SERVICE BULLETIN

PART II - TAIL ROTOR FORK BOLT REPLACEMENT

HN-212.2*
DN-153.2*
EN-43.2*
FN-32.2*

Figure 1. Inspection of Tail Rotor Fork Bolt.

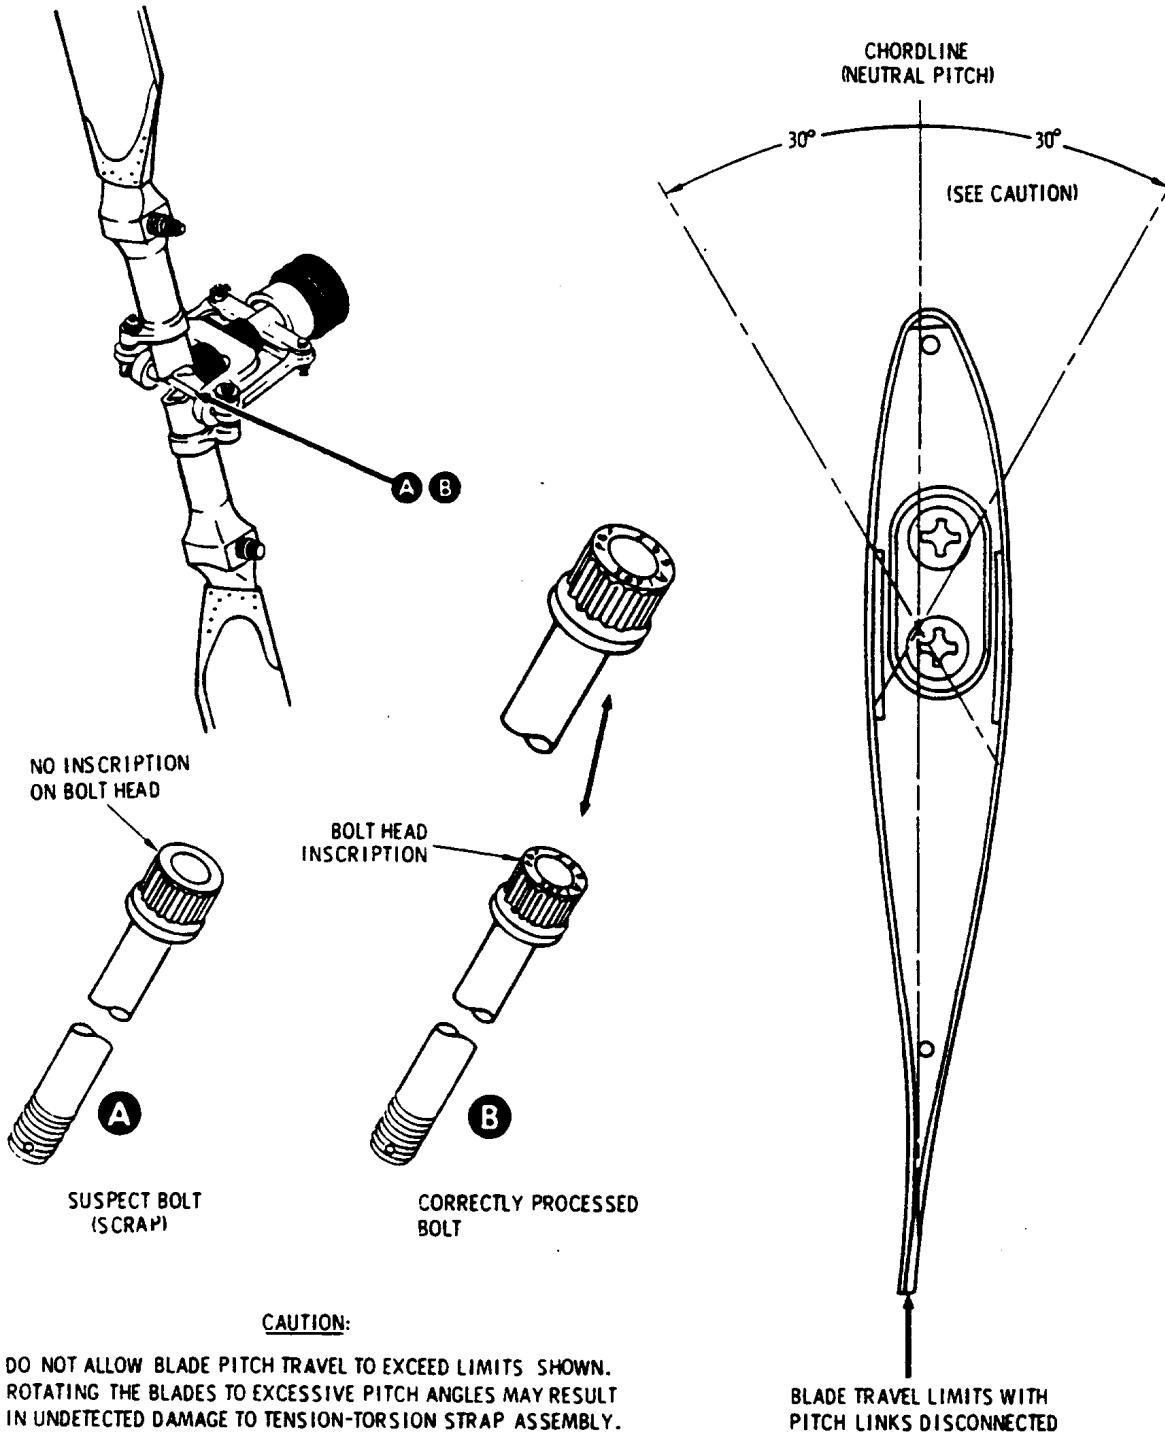
- a. Visually inspect all Spares inventories and tail rotor fork bolts installed on helicopters and tail rotor assemblies for proper inscription on the head of the bolt (see Figure 1).

- Uninscribed tail rotor fork bolts on helicopters shall be replaced, proceed to **Part II**.
- Remove all uninscribed tail rotor fork bolts from Spares inventories and scrap those fork bolts.

- When the blade and hub assembly is removed from the helicopter, and at all times when the pitch control links are disconnected, **DO NOT** allow blade pitch to exceed 30 degrees from neutral position (see Figure 1). This is equal to blade pitch control movement of approximately one inch in either direction. Unrestricted rotation of blades on hub can excessively bend or stretch strap pack assembly and cause undetected damage to tail rotor assembly when reassembled.
- Do not remove hub-to-drive fork hinge bolt to remove tail rotor assembly. Damage to strap pack may occur.

- A MS21206C4 washer must be installed with a 369A1602-3 tail rotor fork bolt.
4. Install a 369A1602-3 fork bolt along with a MS21206C4 washer with the countersunk side towards the bolt head and reassemble hub and fork unit (HMI Appendix C and Component Overhaul Manual, Part VII).
 5. Perform testing and balancing procedures (HMI Appendix C, Part VIII and Component Overhaul Manual, Part VII).
- b. Record compliance with Part II of this Notice in the Compliance Record section of the helicopter Log Book.
